VOLLMER ROAD (NORTH)

STREET IMPROVEMENT PLAN

AS-BUILTS
04/13/2026

VOLLMER ROAD (NORTH)
 ROADWAY PLAN & PROFILE

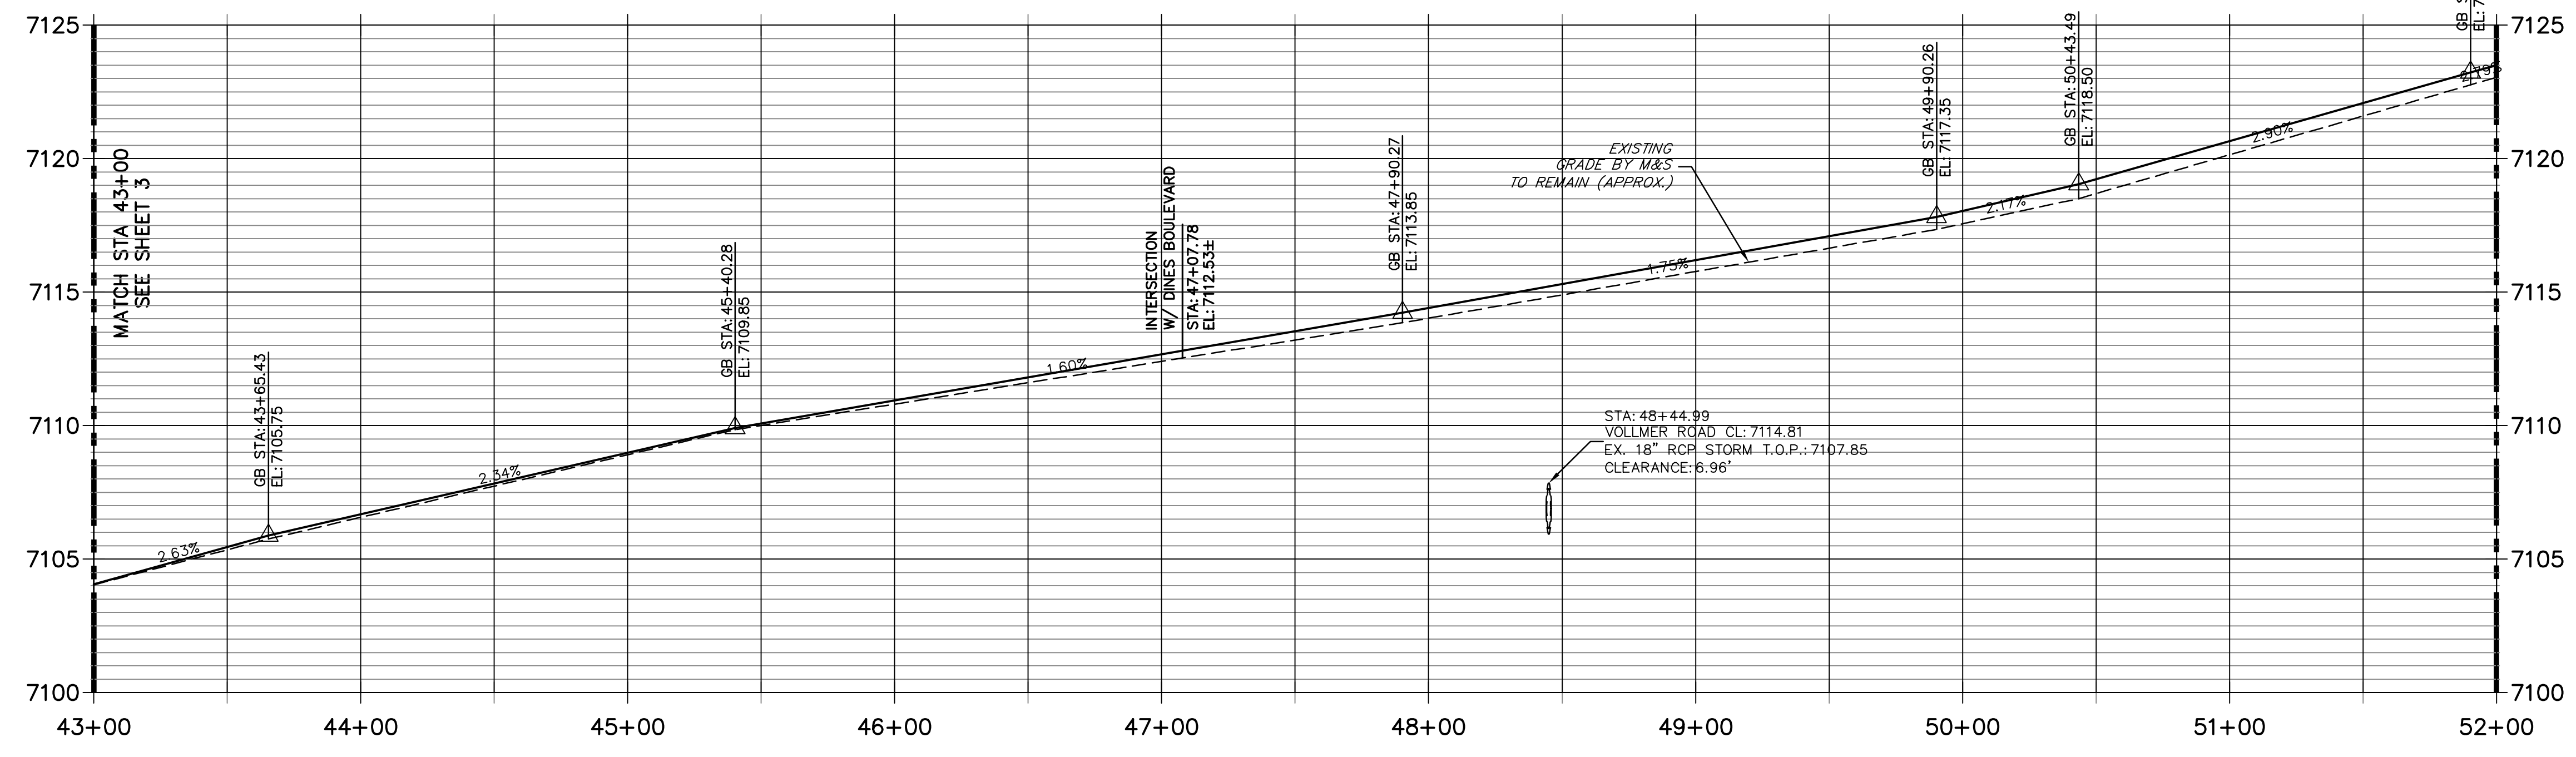
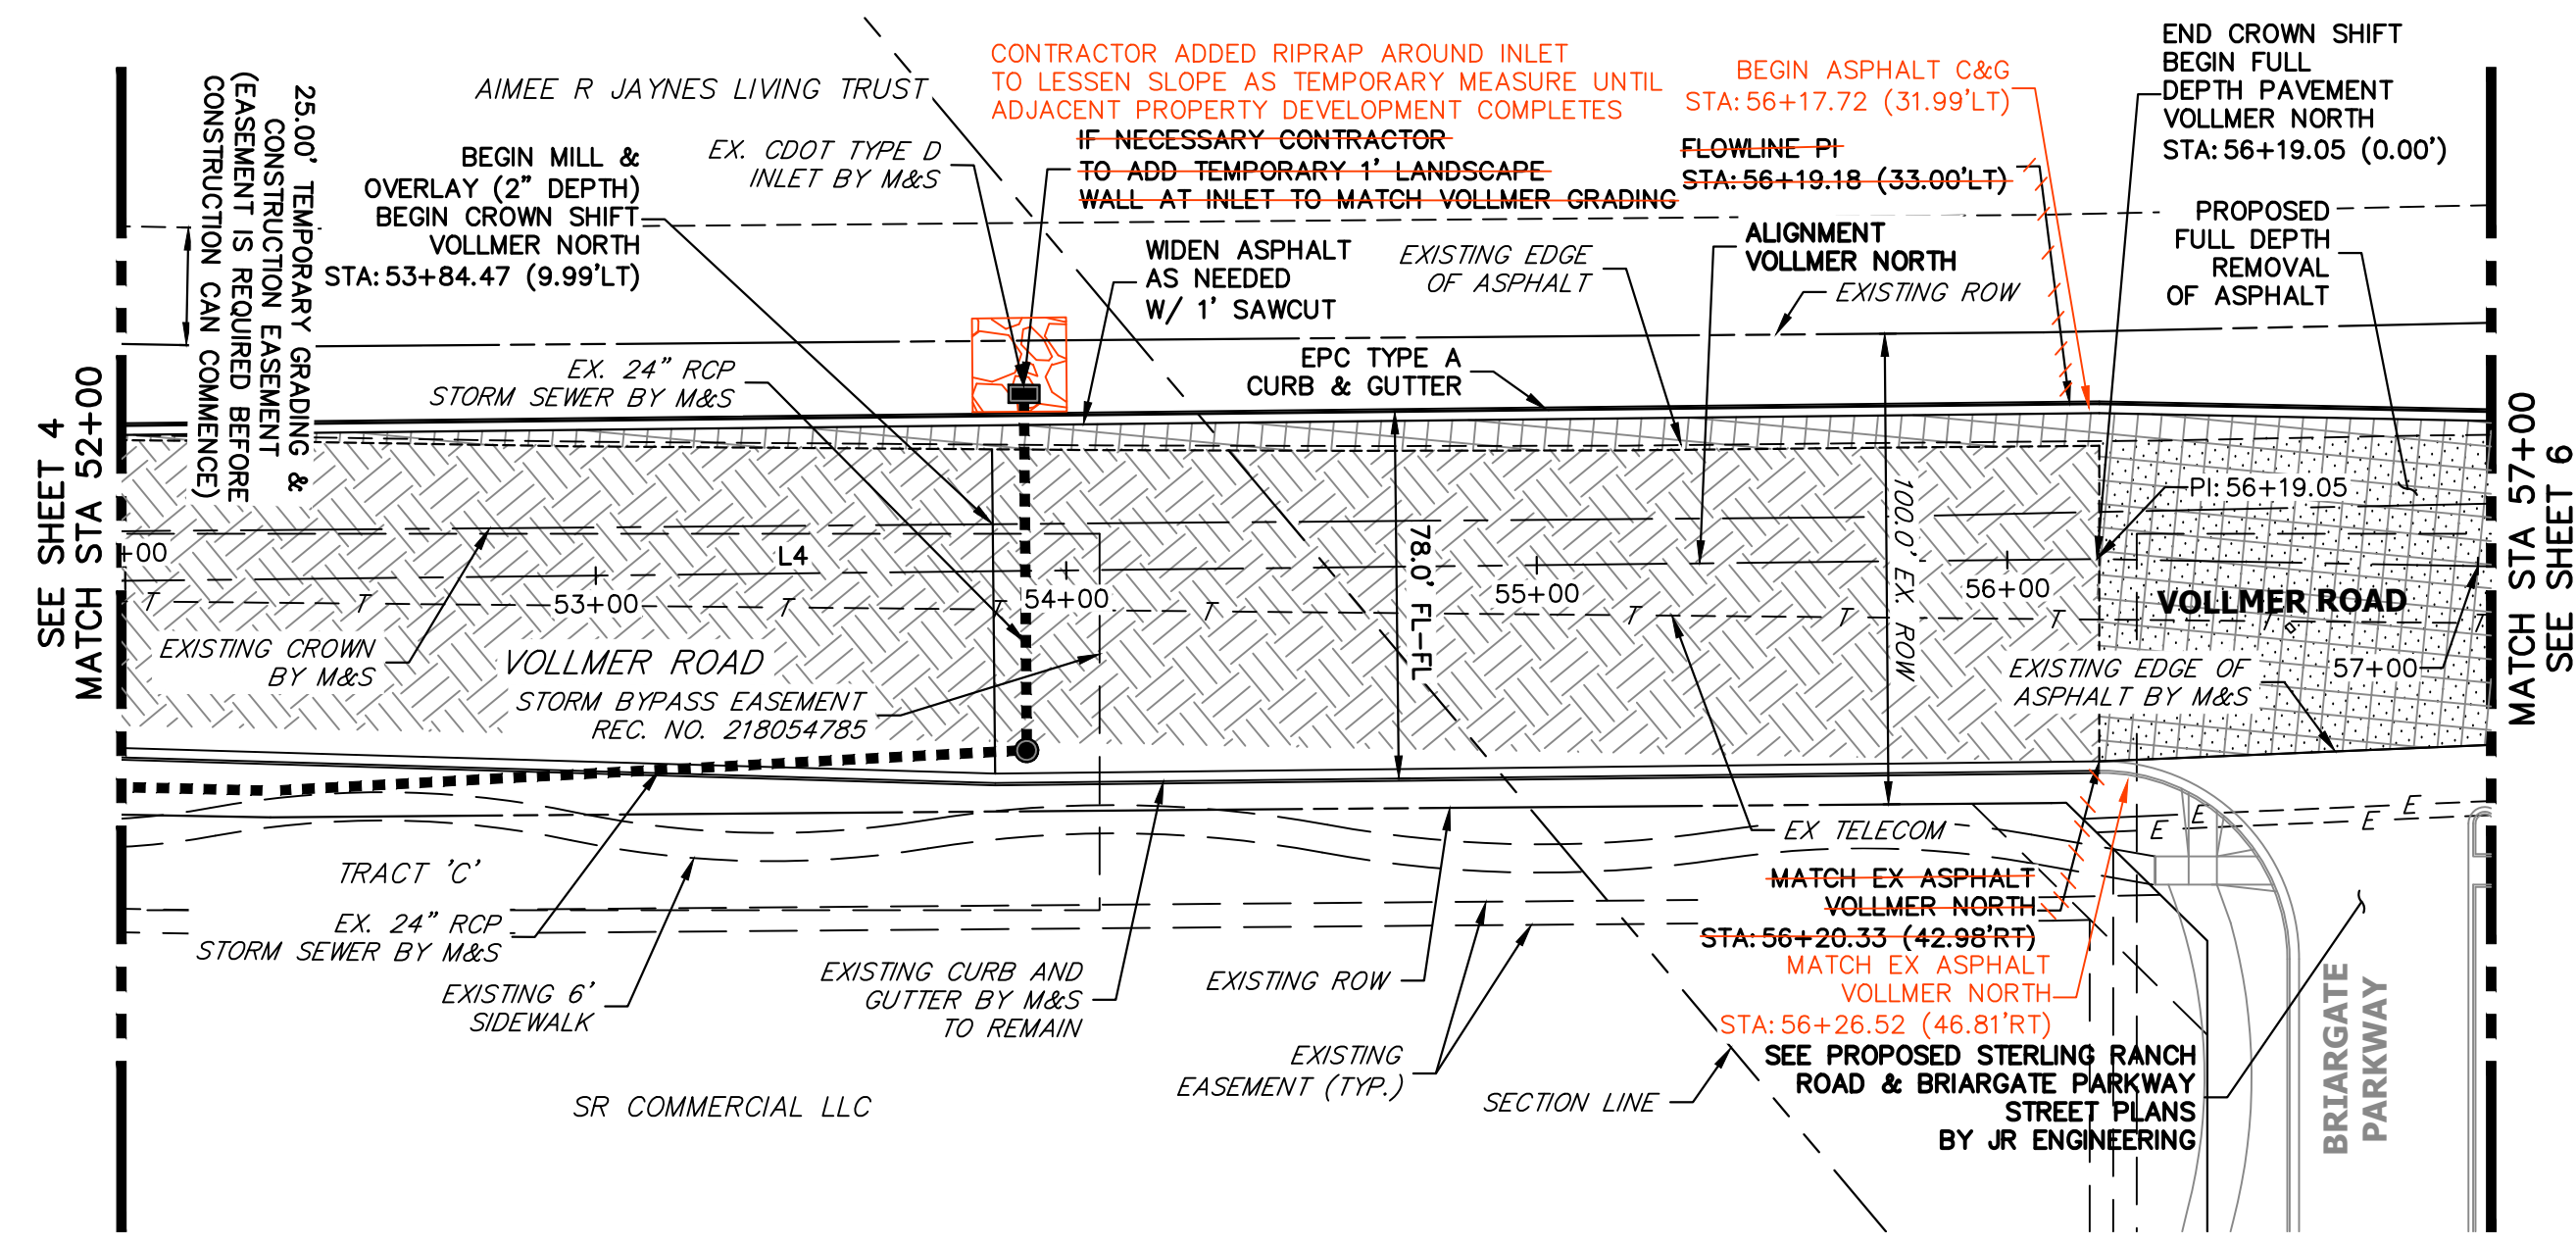
Unresolved Review 1 and 2 comment.
 Review 3 comment:
 The developer/contractor flow filled this pipe with slurry recently on 4/24. Please update this note to be accurate.
JR Response: Addressed

VOLLMER ROAD (NORTH)
ROADWAY PLAN & PROFILE

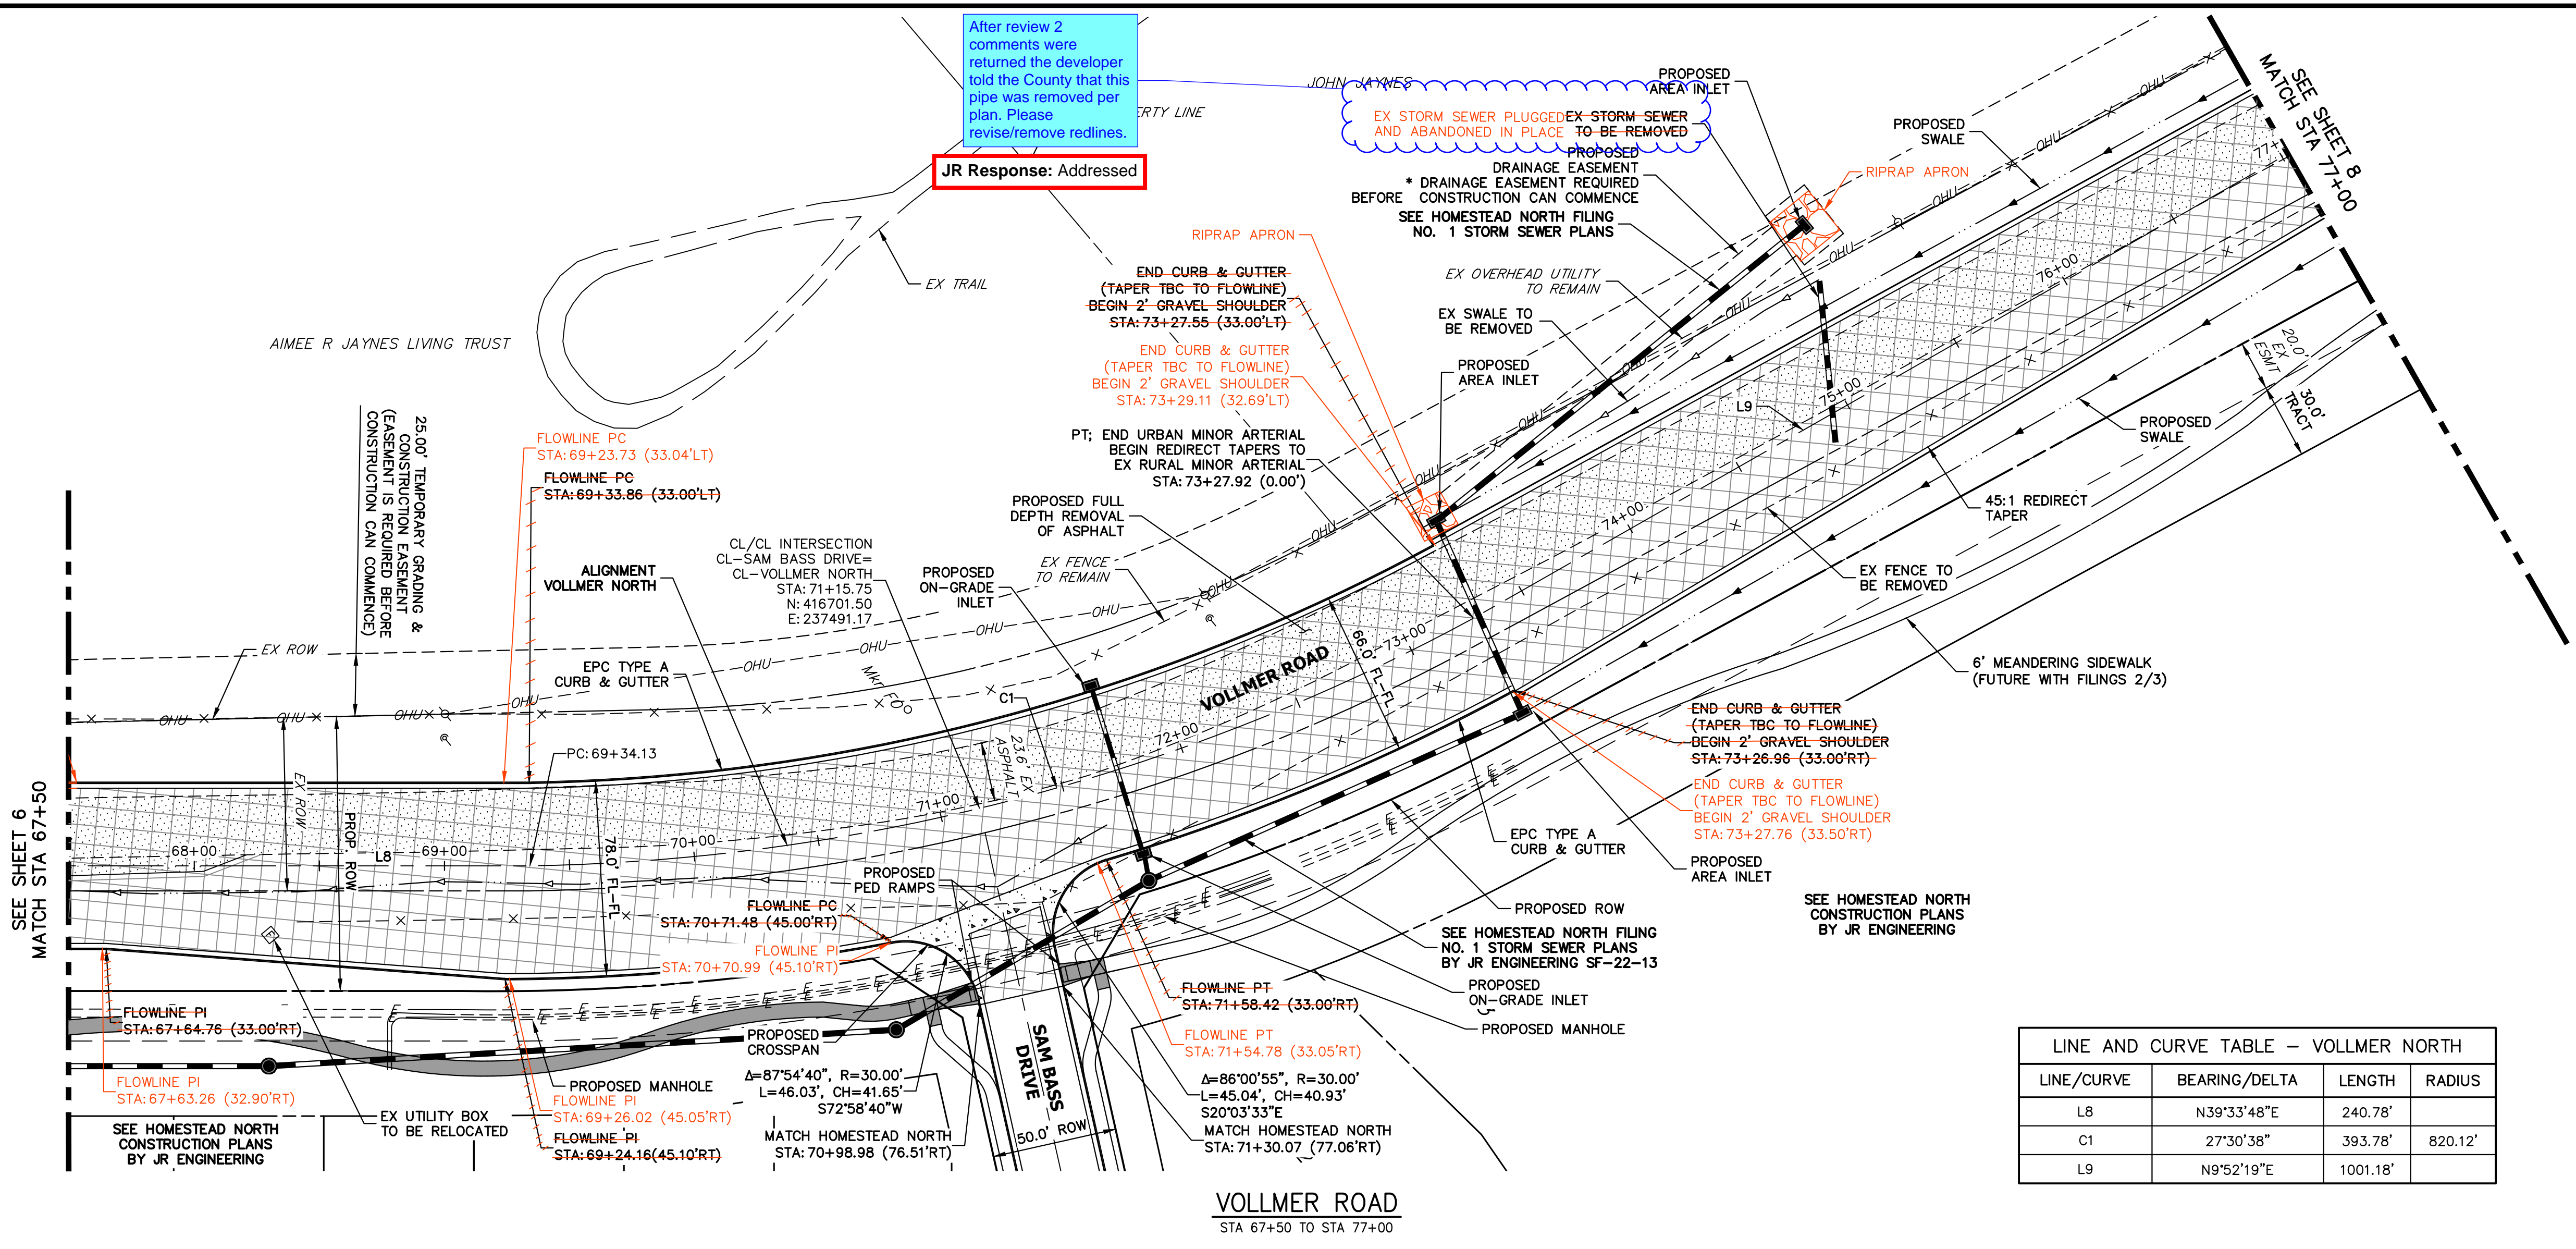
After review 2 comments were returned the developer told the County that this pipe was removed per plan. Please revise/remove redlines.
JR Response: Addressed
